Access Compliance Report Public Rights-of-Way (Curb Ramps)

Main Street: NEWPORT_BLVD		Cross Street: N/A		Location:	NW
ADA ID: RPAT220225171427	Ramp Type:Type 1 - Perpendicular	Initial Pass/Fail: Fail	Overall Compliance: No	Severity Score:	15

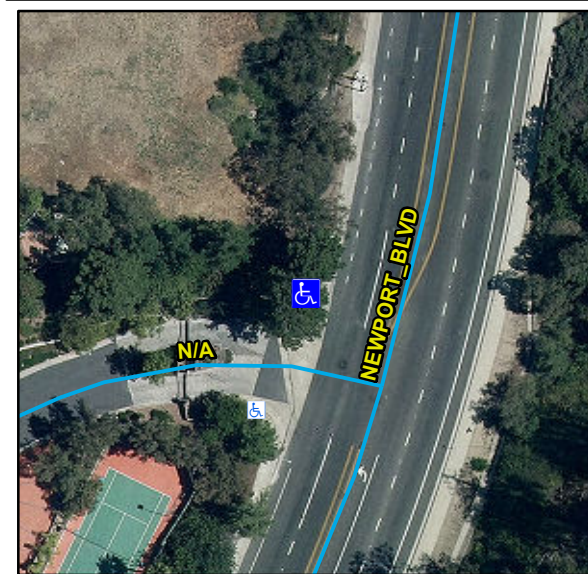
Compliance	Description	Data	Compliance	Description	Data
N/A	Ramp Length (in)	89	N/A	Flare Type LT	
Yes	Ramp Width (in)	48			N/A
No	Ramp Run Slope (%)	8.5	N/A	Flare Slope LT (%)	N/A
Yes	Ramp Cross Slope (%)	4.9	N/A	Flare Traversable LT	N/A
N/A	Landing Present	N/A	N/A	Flare Type RT	
N/A	Landing Length (in)	N/A			N/A
N/A	Landing Width (in)	N/A	N/A	Flare Slope RT (%)	N/A
N/A	Landing Run Slope (%)	N/A	N/A	Flare Traversable RT	N/A
N/A	Landing Cross Slope (%)	N/A	N/A	DWS Provided	N/A
N/A	Landing Movement Obstructed?	N/A	N/A	DWS Contrast	N/A
	Landing Movement Type	N/A	N/A	DWS Length (in)	N/A
N/A	Landing Shared	N/A	N/A	DWS Full Width	N/A
N/A	Clear Space	N/A	N/A	DWS Offset Left (in)	N/A
N/A	Clear Space To Crosswalk (in)	N/A	N/A	DWS Offset Right (in)	N/A
N/A	Marked Crosswalk 1	No	N/A	Marked Crosswalk 2	N/A
	Crossing 1 Direction	N		Crossing 2 Direction	N/A
	Marked Crosswalk 1 Width (in)	N/A		Marked Crosswalk 2 Width (in)	N/A

N/A	Ramp Inside Crosswalk 1	N/A	Yes	Ramp Inside Crosswalk 2	N/A
	Crossing 1 Slope (%)	8		Crossing 2 Slope (%)	N/A
	Crossing 1 Cross Slope (%)	7.6		Crossing 2 Cross Slope (%)	N/A
N/A	Gutter Ponding	N/A	N/A	Curb Slope	2.4
Yes	Gutter Lip Height (in)	0		Road Run Slope (%)	N/A
N/A	Gutter Run Slope (%)	N/A		Road Cross Slope (%)	N/A
N/A	Gutter Cross Slope (%)	N/A			
Yes	Overall Surface Condition: Acceptable		Yes	Perp Joint Present	Yes
	Cross Gutter Present?	Yes		Spandrel Present?	Yes
	Replace Cross Gutter?	No		Replace Spandrel?	No

Remove & Replace Entire Ramp.

R304.2.2, STD 1115
